Product Change Notice

Issue Date: 1st July-2021

Introduction of replacement die for below part numbers.

Figure 1

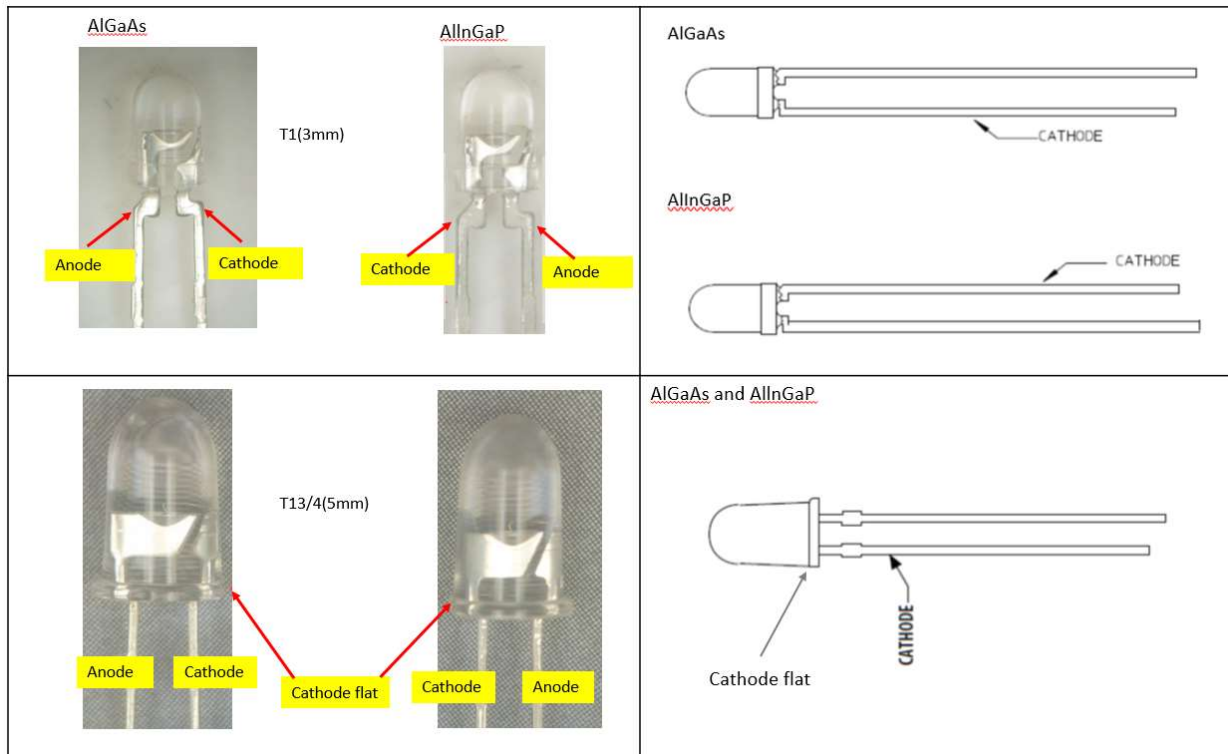
Group 2 (AlGaAs LED Lamps) will have a change in form as shown in Figure 1.

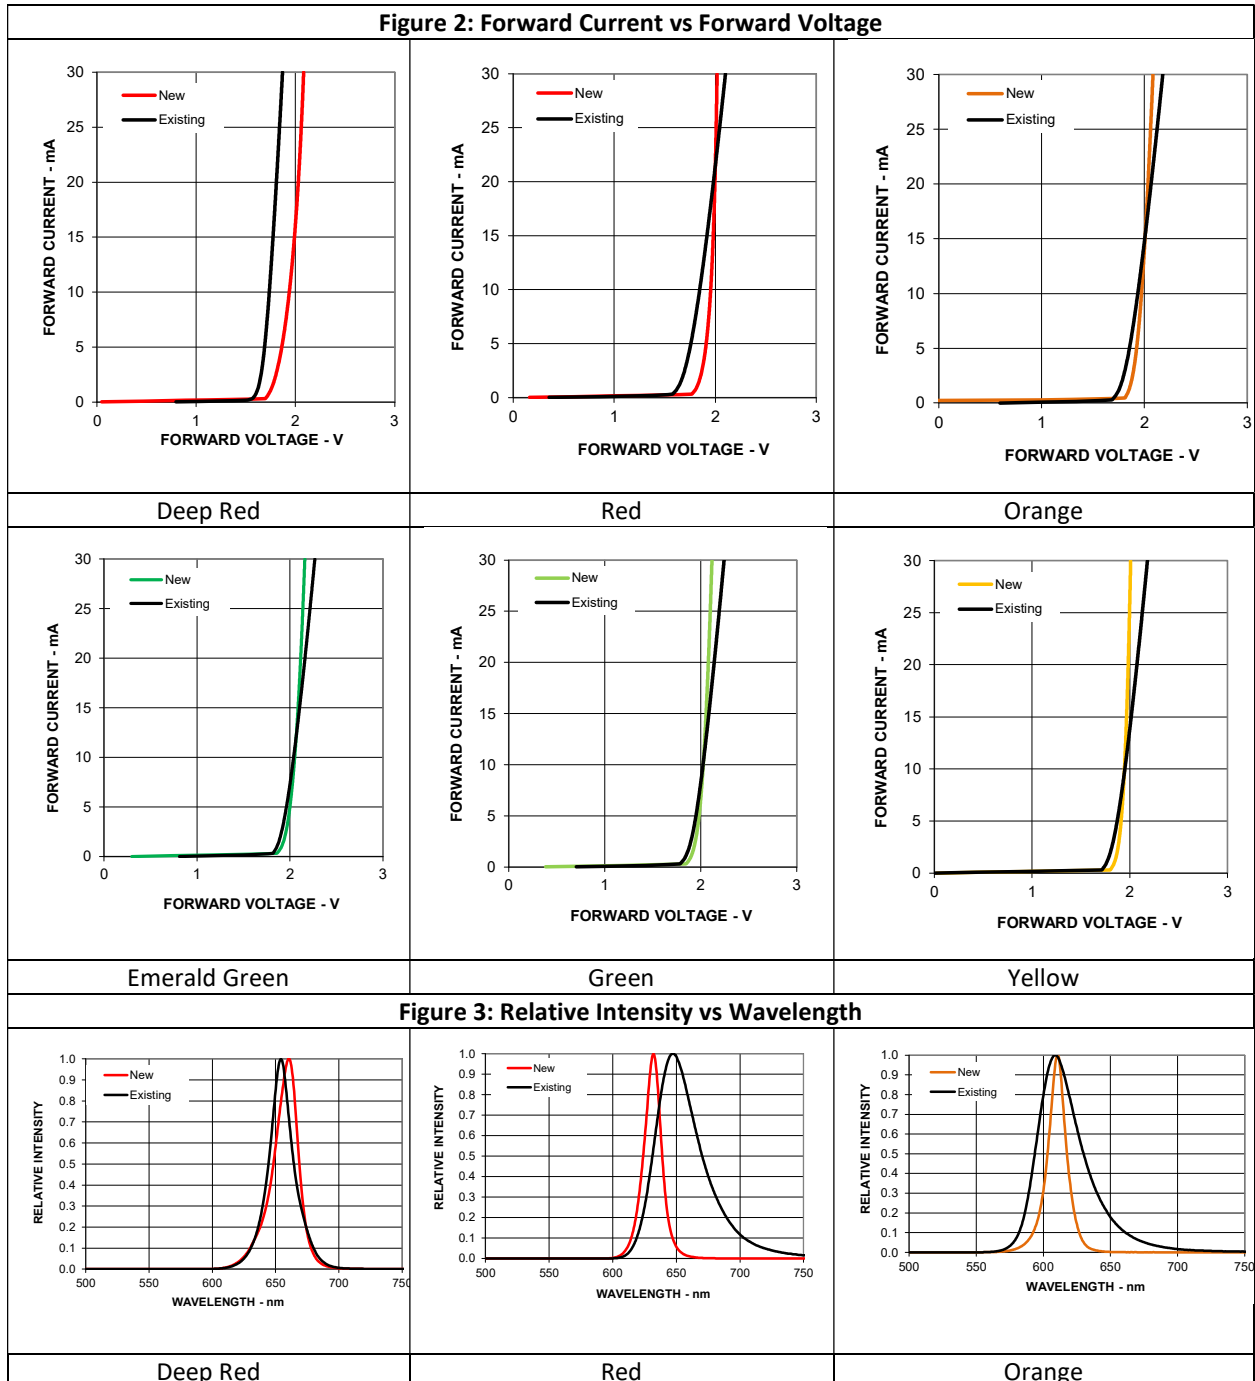
Following are the changes in product characteristic for both Group 1 and 2 of the LEDs.

1. Forward Current vs Forward Voltage.
2. Relative Intensity vs Wavelength
3. Relative Intensity vs Forward Current
4. Luminous Intensity : Some part numbers will experience higher typical intensity (refer to individual datasheet for details)
